**Re: Application for Planning Permit (DA2012/00200)**  
**Recycling & Waste Disposal, Glenstone Road, Bridgewater**

Thank you for your correspondence dated 13/8/21. I write to provide you with the additional information sought under Section 54 of LUPAA.

SCALE	PAPER
1:600	(A3)
JOB NUMBER	DRAWING
47359HC-11A

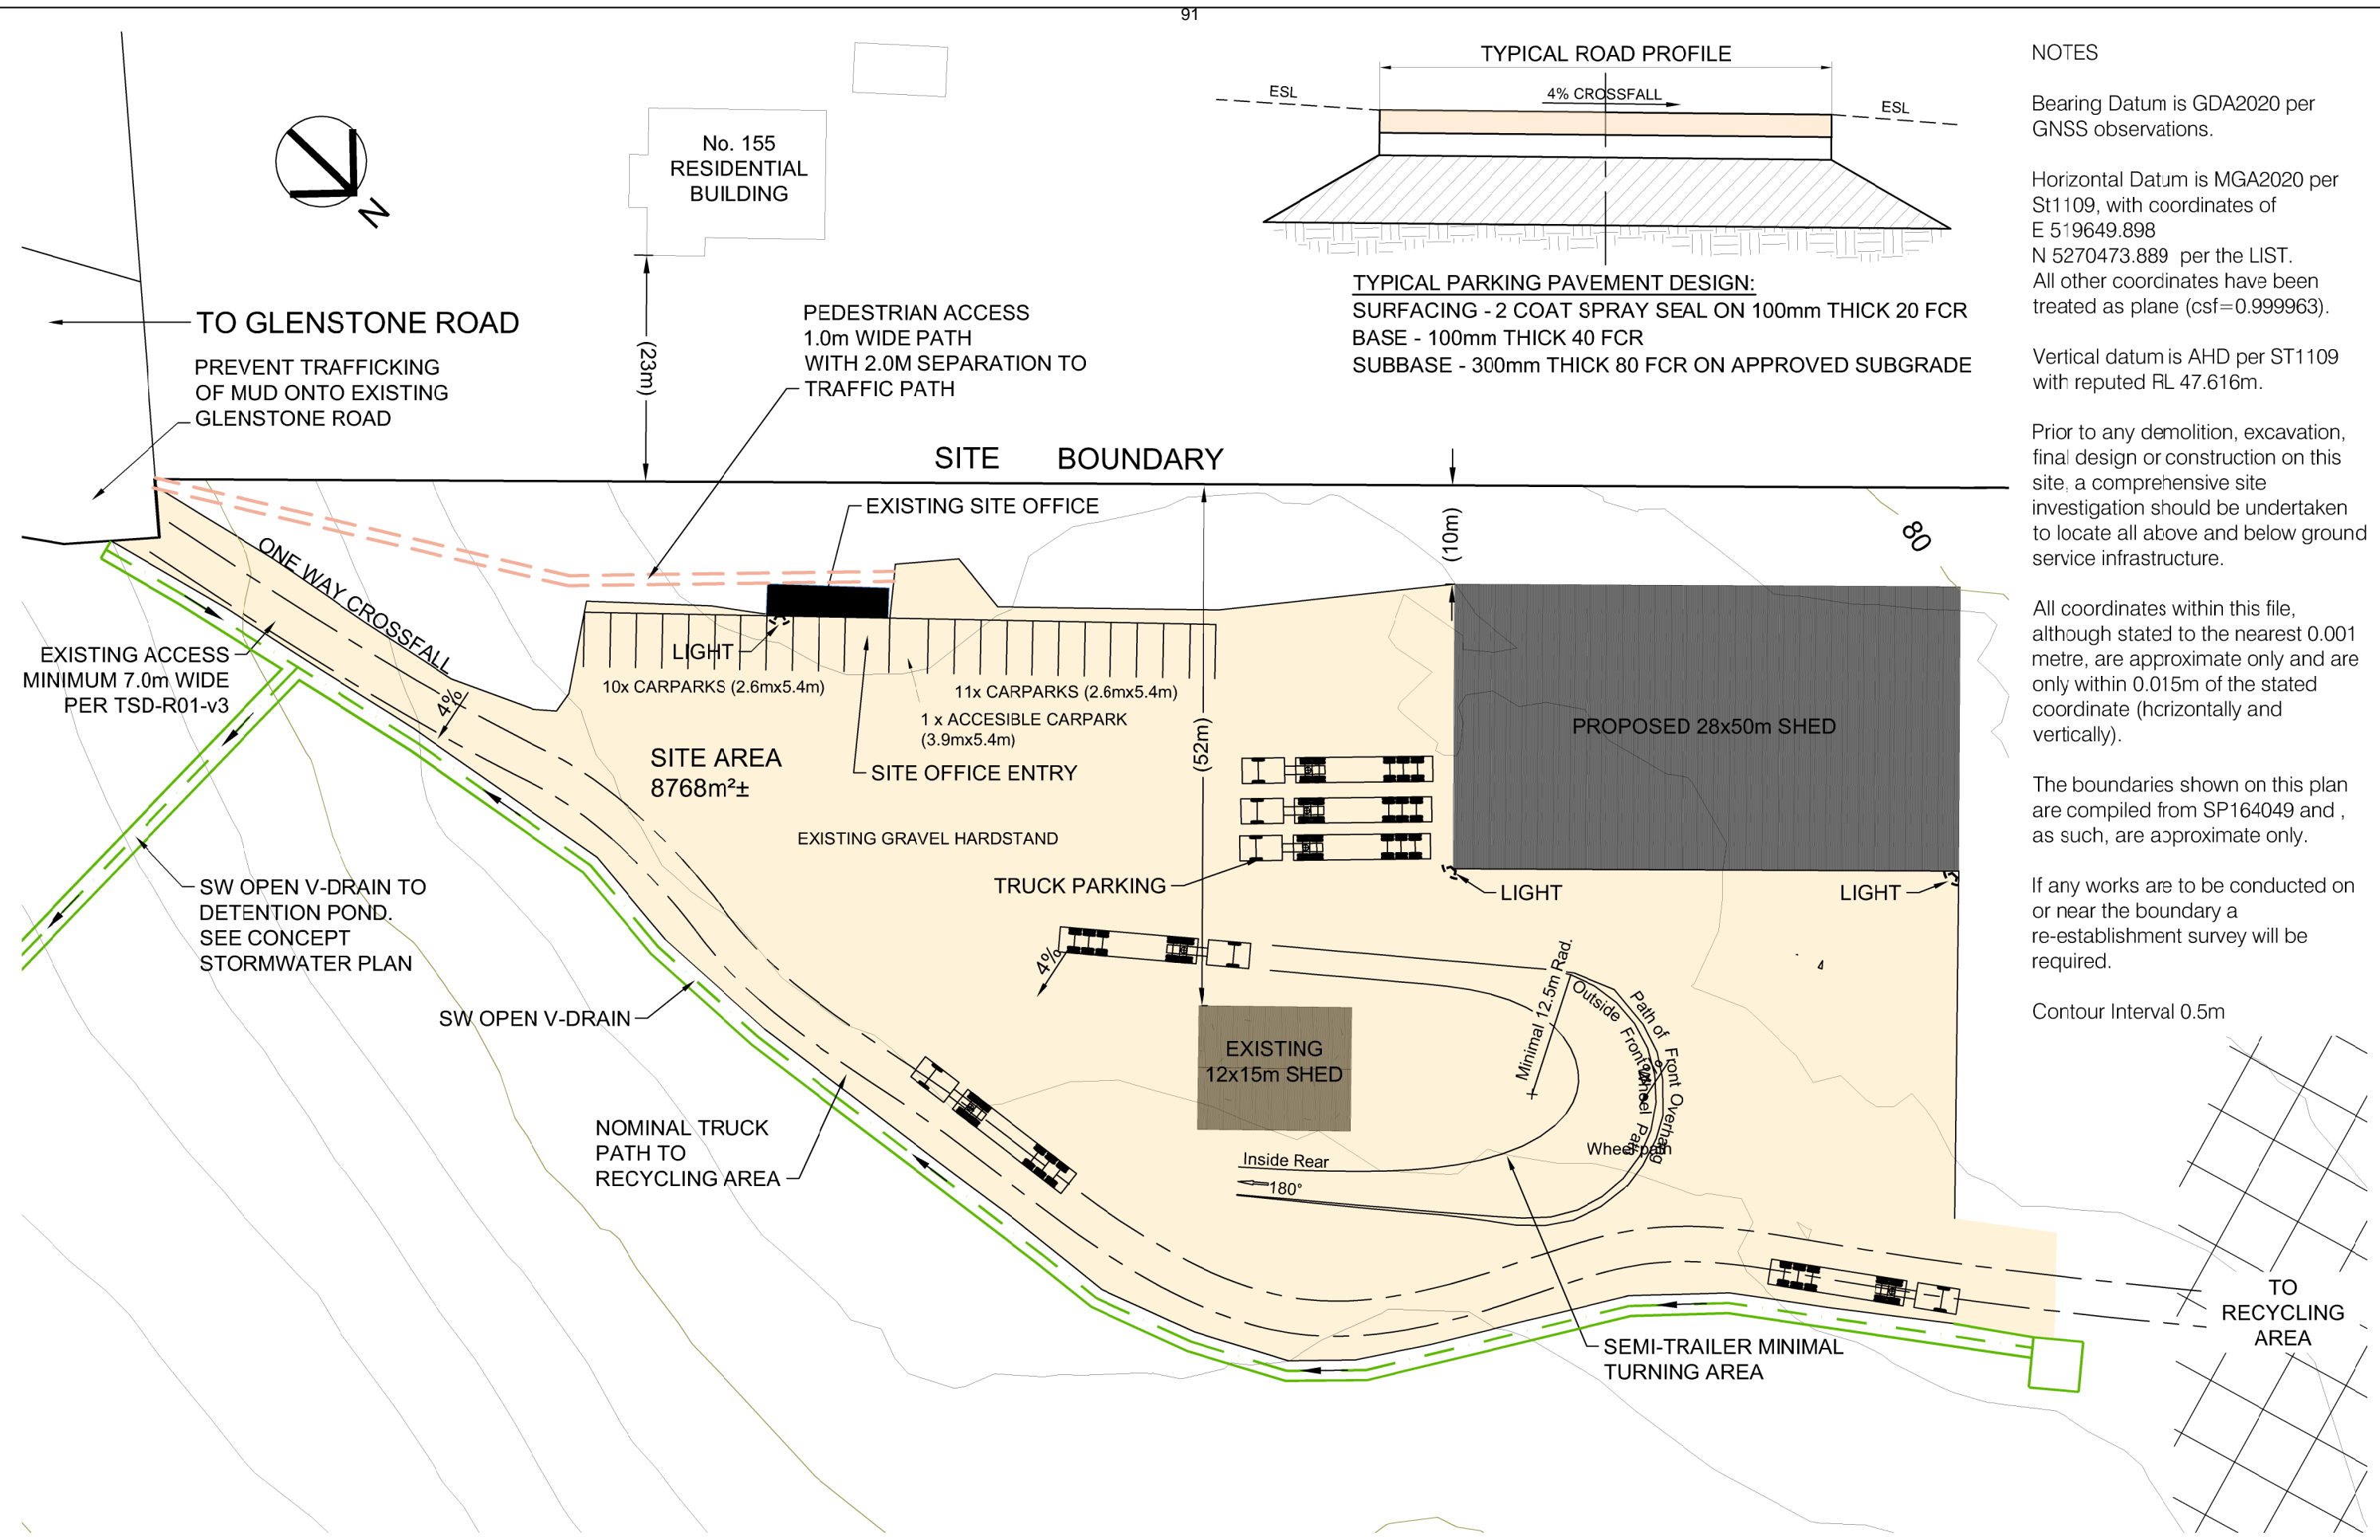
Twenty-two spaces are provided on the site plan to meet the scheme requirements, but it should be noted that this is considered excessive to the actual needs of the development. The business owner has advised that ten spaces are more than sufficient to provide for staff parking, the parking of vehicles used on site when not in operation and the occasional client who may attend for a meeting.

An updated parking plan is provided as an attachment to this response.

Please refer to the attached updated plan – 47359HC – 11 (Parking Plan)
